ABP— 314485-22

Planning Appeal Online Observation

Observation on a Planning Appeal: Form.

Dublin Airport, Co Dublin

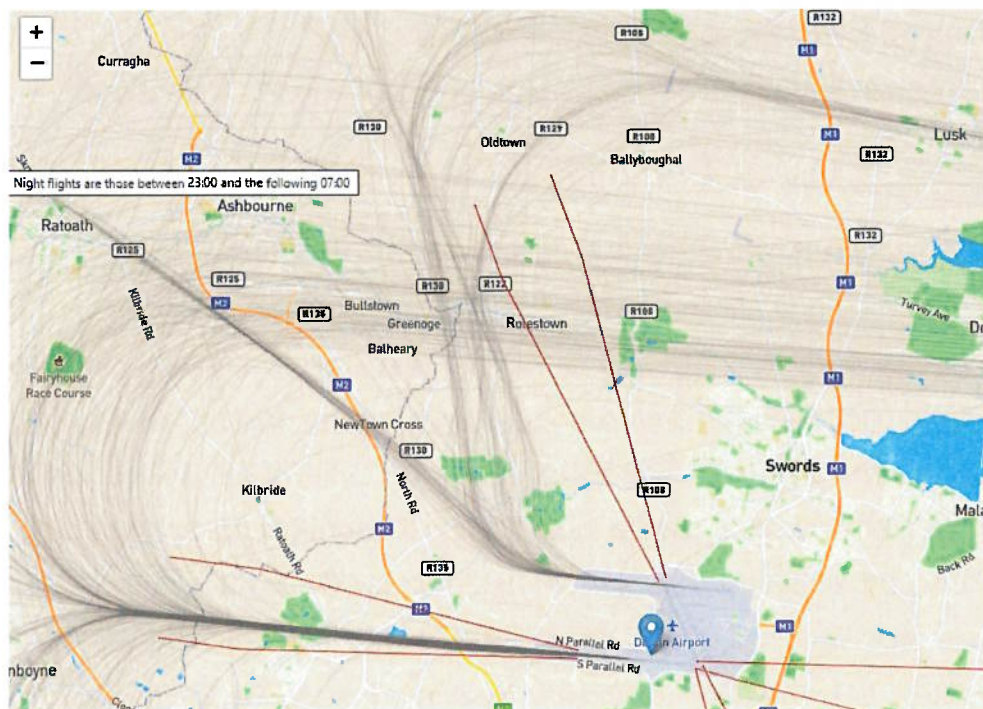
- Flying divergent flight paths on the North Runway for Westerly operations contravening the EIS of 2007
- Divergent flight paths currently in operation do not align with EIAR for this current planning application that is under appeal

- 30-degree divergence was not proposed in the 2016 consultation
- Condition 3 of planning does not allow for dual runway departures under Option 7b
- Flight paths used in Insulation Scheme approved by Fingal County Council in 2016, based on 2007 planning permission, show straight out operations

- Departures on North Runway on August 25-27th and all dates of westerly departures since opening are showing divergent routes contravening the planning permission from 2007
